SUBJECT: Transmittal of Bridge Scour Assessments

SUBJECT: BRIDGE SCOUR INFORMATION (SCOUR CRITICAL)

BRIDGE SCOUR REPORT

FINAL REPORT OF CODE T BRIDGE FOUNDATION INVESTIGATION
BRIDGE # 640012
NEW HANOVER COUNTY
ROUTE US 74 & 76
INTRACOASTAL WATERWAY

BENT
8

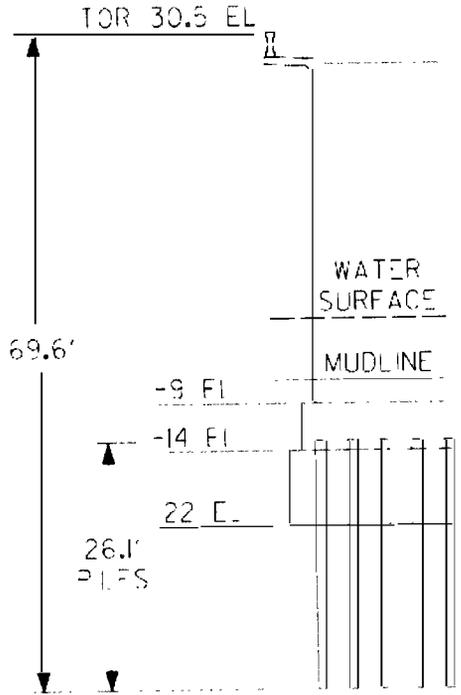
1991 prompt action repair on footing No. 1 of bent 8. Current scouring is occurring at footing No. 2 of bent 8 and extends downstream along the eastern face of the pier. A 2004 prompt action was issued for the scouring occurring on footing No two and was re-issued in 2007.

A 2002 inspection found scouring conditions beneath the eastern side of bent 8 starting at footing No. 2 and extending downstream along the face. A 2002 prompt action report was issued with no remedial work performed. Prompt action was re-issued in 2004 due to increased scour and severed foundation piles. A new prompt action was issued in 2007. The latest underwater inspection report stated that the scour mentioned in the 2004 inspection was still active at that time.

Monitor Bent 8 and 9 for exposed piles or timber piles damaged by marine borers.

Increase U/W inspection frequency to every 2 years. If no problems are found after two cycles, return to 4yr frequency
